SUBJECT: Transmittal of Revised Westinghouse Proprietary and Non-Proprietary Responses to U.S. Nuclear Regulatory Commission Requests for Additional for the AP1000 Application for Design Certification

Westinghouse Revised Non-Proprietary Responses
to US Nuclear Regulatory Commission
Requests for Additional Information
dated March 17, 2003

AP1000 DESIGN CERTIFICATION REVIEW

Table 251.005-1

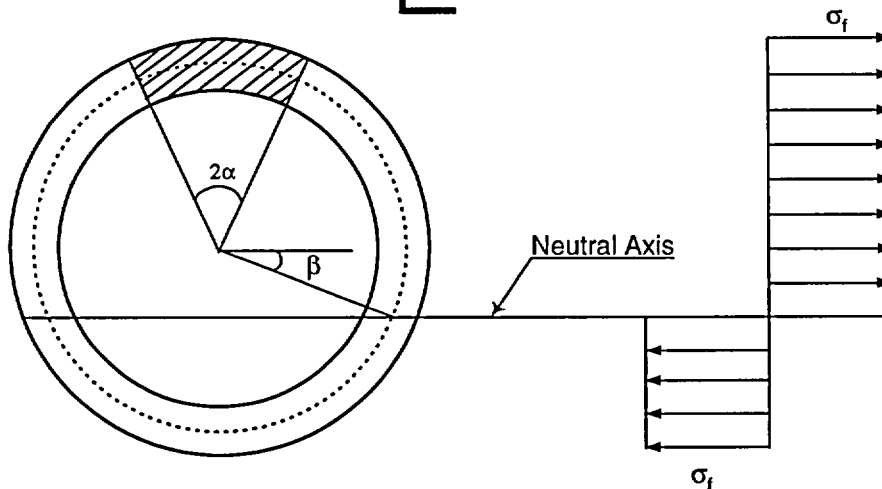
As discussed in a teleconference with Westinghouse and NRC on March 10, 2003, in order to perform confirmatory calculations related to RAI 251.005, the staff requests the additional information. Please provide the following information related to Figure 3B-12:

Westinghouse Additional Response:

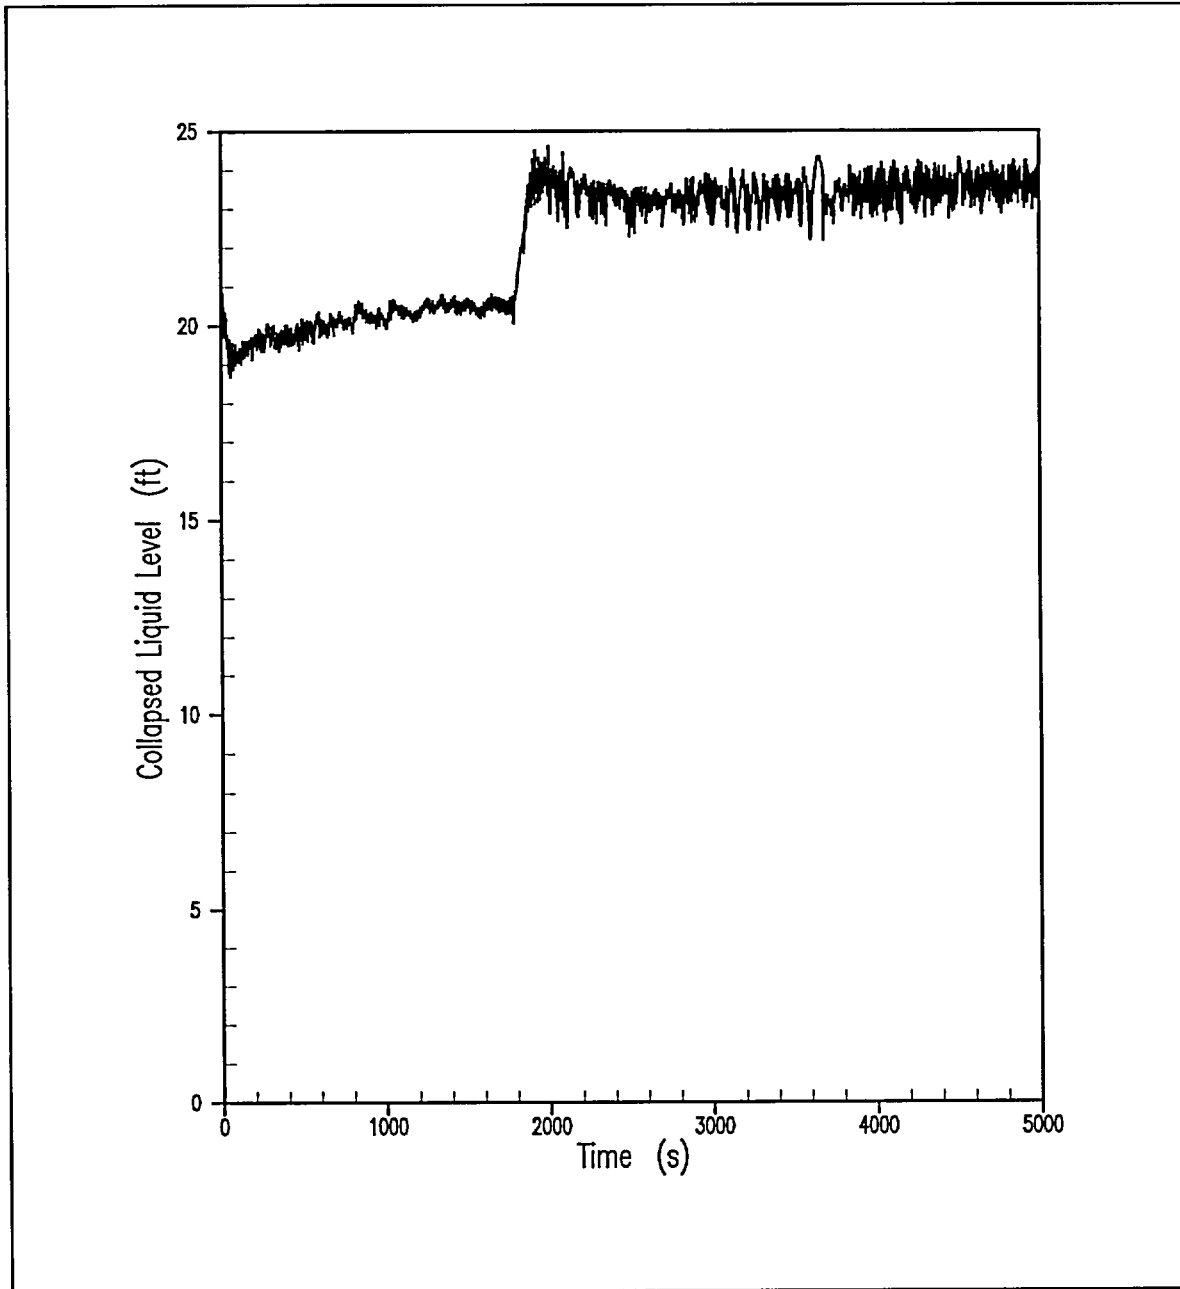
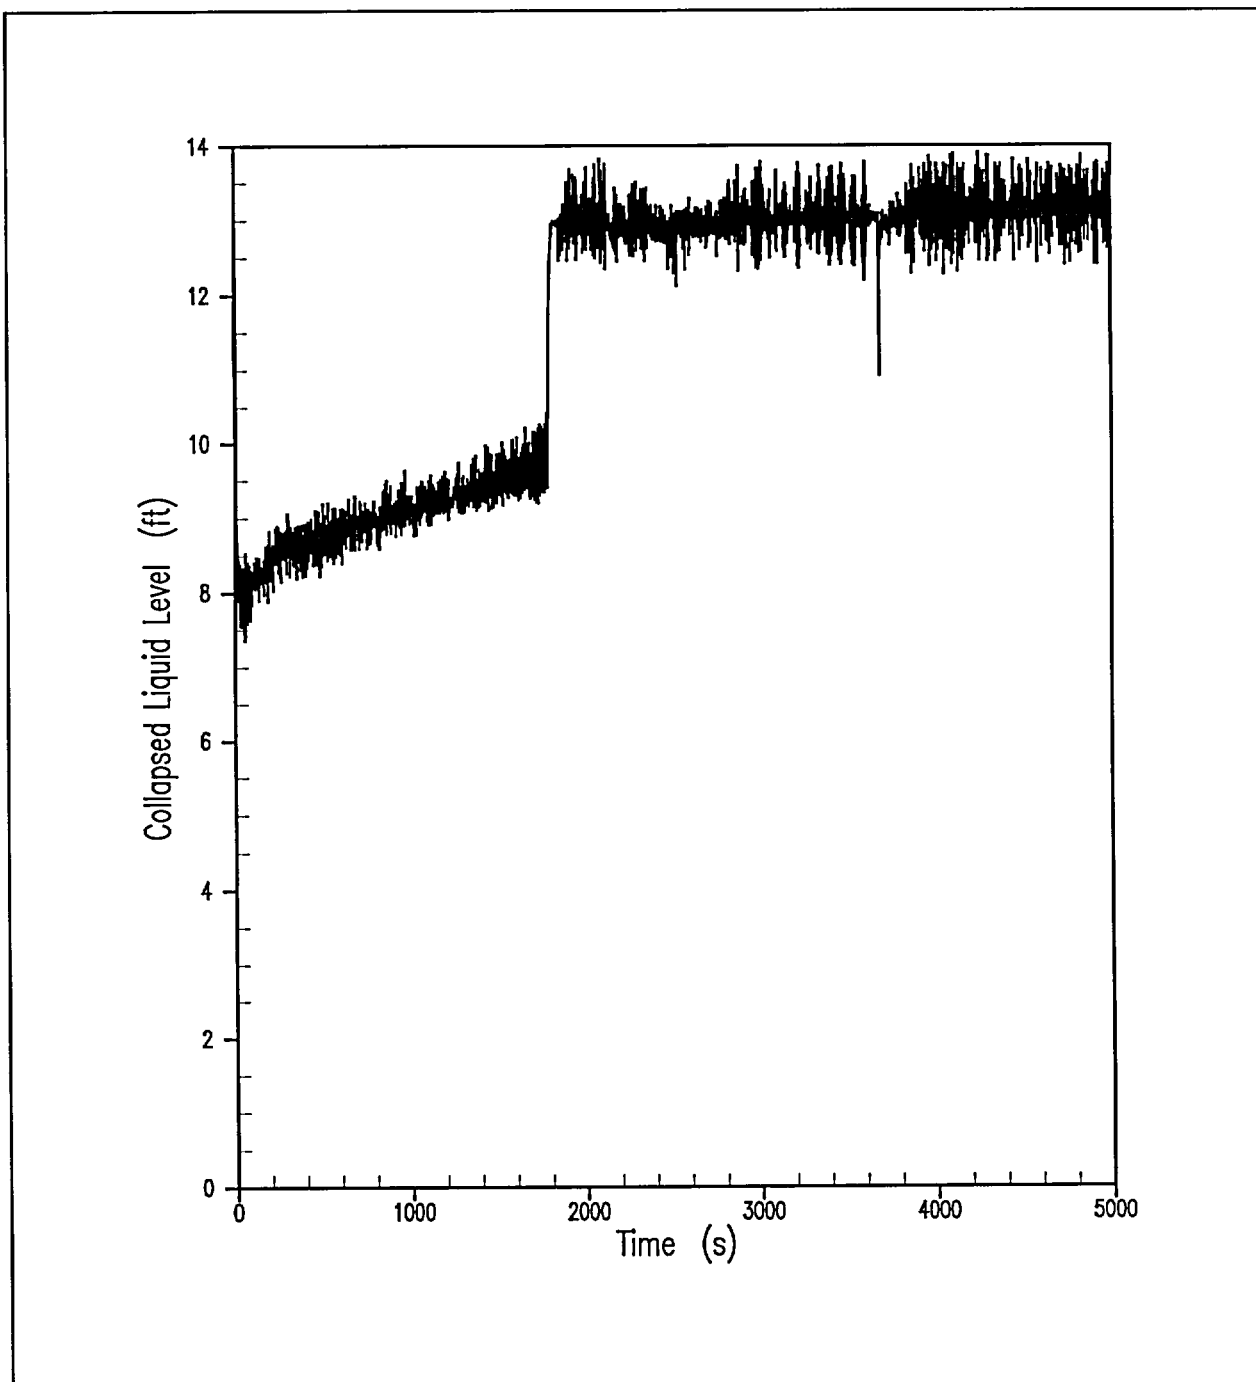
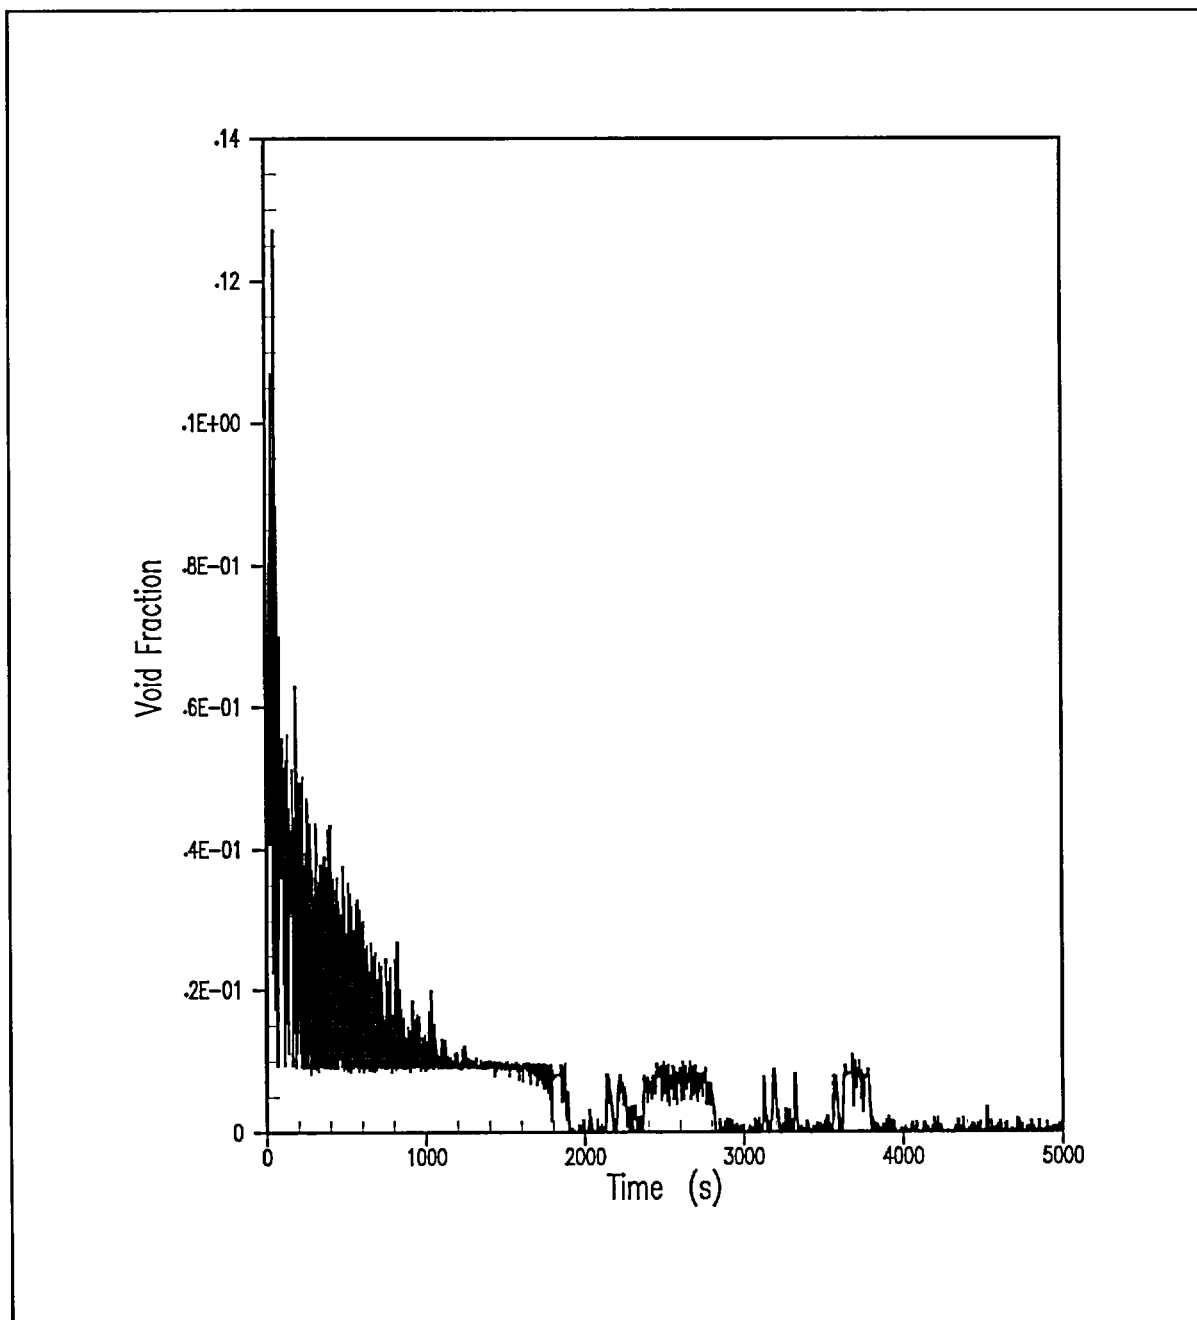
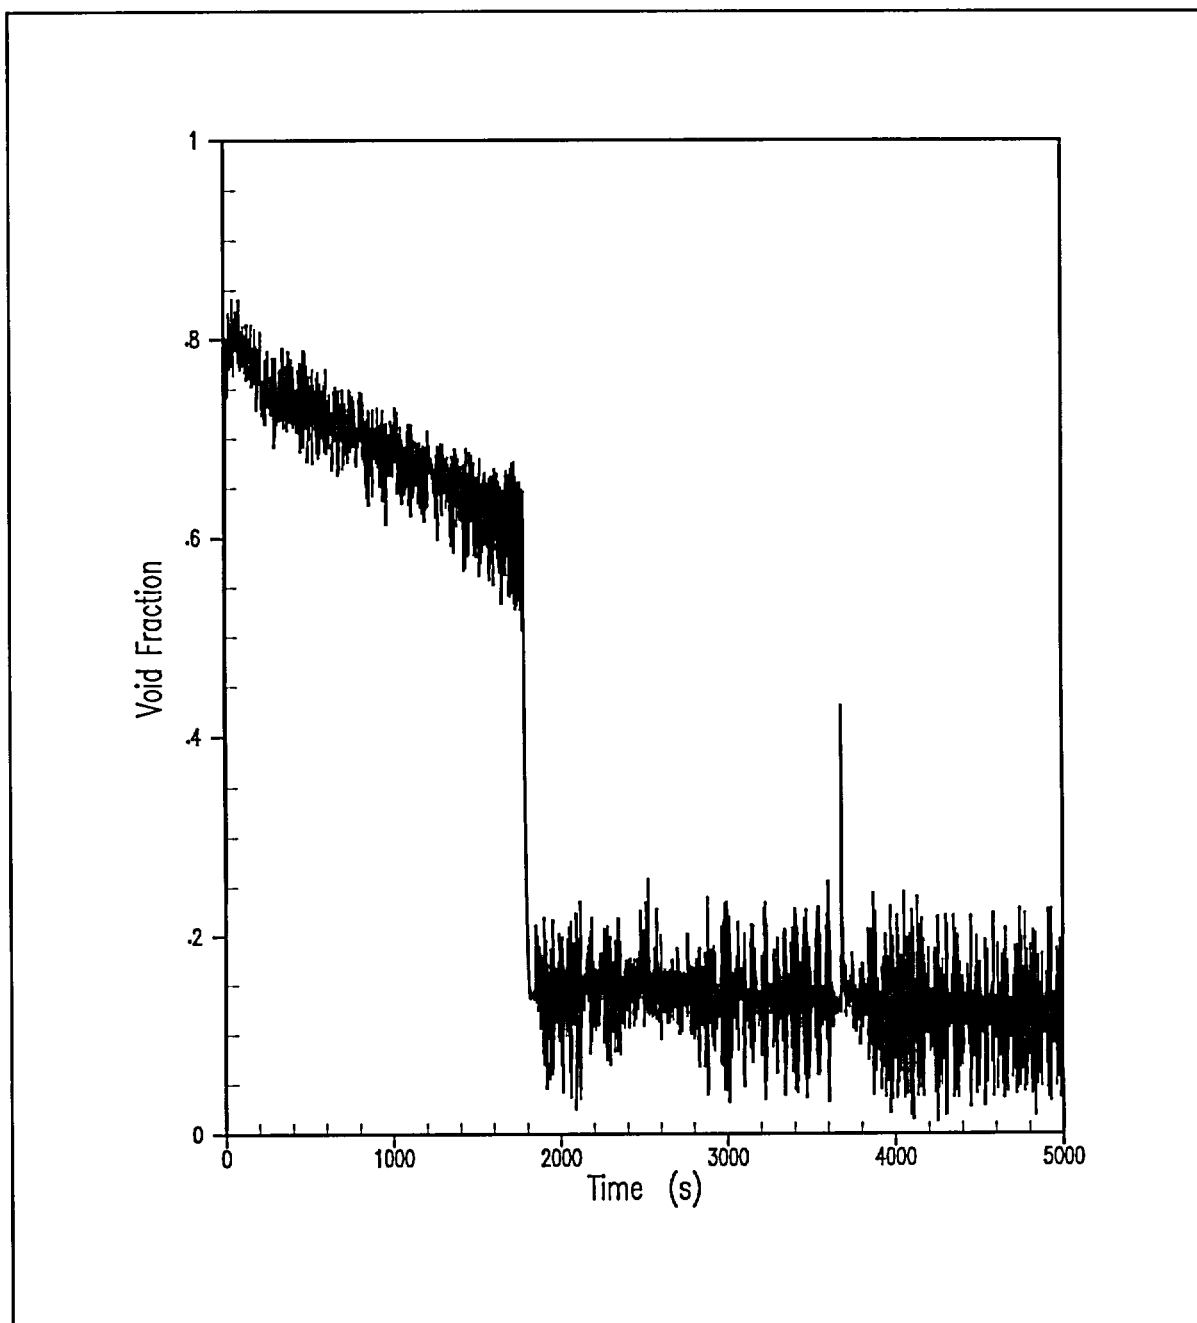
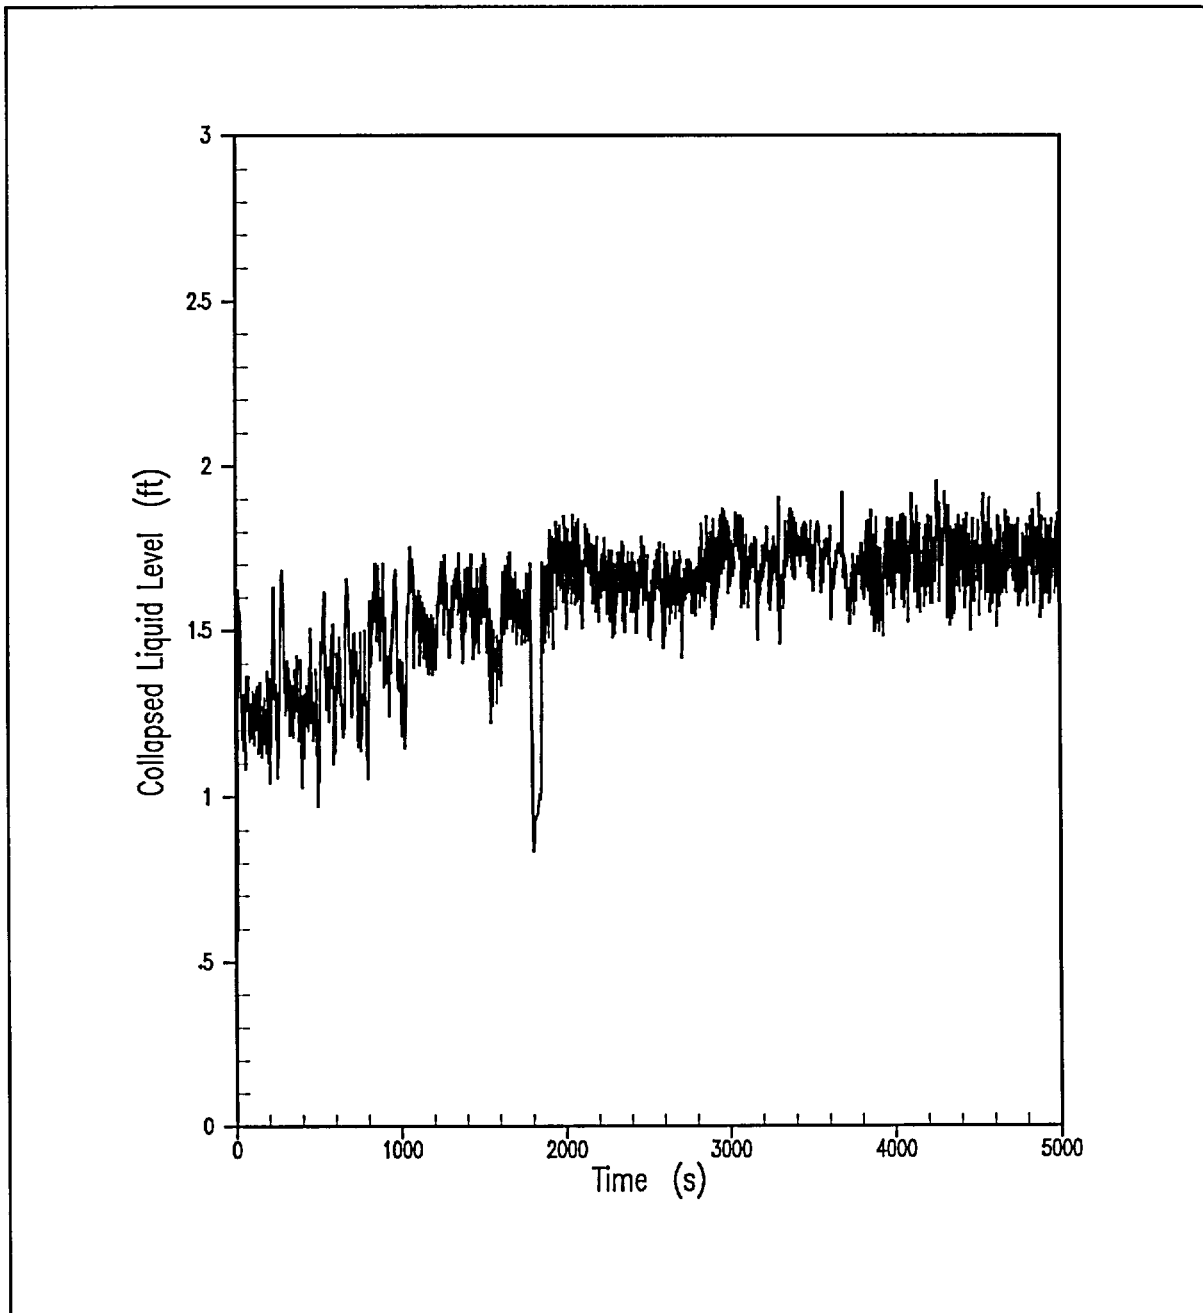
Will that steam velocity be able to entrain and remove liquid from the core? (Note, it is not feasible to draw this conclusion from the information in the code applicability report without extensive calculations.)

The question is concerned with the removal of liquid from the AP1000 core / upper plenum at a minimum steam velocity condition. The concern is whether there exists sufficient liquid carryover out the ADS-4 valves post-LOCA to prevent the potential for boron precipitation in the reactor vessel. As was demonstrated for the AP600, liquid carryover from the ADS-4 valves prevents the reactor vessel boron concentration from approaching the concentration where boron would precipitate. A boron concentration of approximately 35,000 ppm at 240F is necessary to cause boron to precipitate out of solution. Bounding calculations performed for the AP1000 have determined that the maximum post-LOCA boron concentration calculated for the limiting long-term cooling analysis cases presented in the DCD is 5500 ppm. This represents a large margin to the value where boron precipitation could be a concern.

A set of figures is provided presenting the results obtained from the WCOBRA/TRAC run for this scenario. Liquid flow through the ADS-4 flow paths is adequate to ensure that boron will not concentrate in the core. As seen on Figure 440.091-15, the average steam velocity through the ADS-4 Stage 4A flow path in the offtake pipe from the hot legs is 95 ft/sec, while in the DCD case the average steam velocity at the same location is almost 300 ft/sec (Figure 440.091-16). Overall, the figures show that amount of liquid carryover is increased for this scenario. As seen in comparison to the DEDVI long-term cooling analysis results presented in the DCD, the vessel injection is greater, and reactor vessel level is higher throughout the transient. This is primarily due to the faster RCS depressurization resulting from all four ADS-4 valves opening. Even though the vapor velocity in the ADS-4 flow paths is reduced, the core remains covered and cooled, and the liquid carry-over out the ADS-4 is increased (when compared to the cases presented in the DCD). Thus boron precipitation in the reactor vessel will not be a concern for the postulated scenario raised in this RAI.
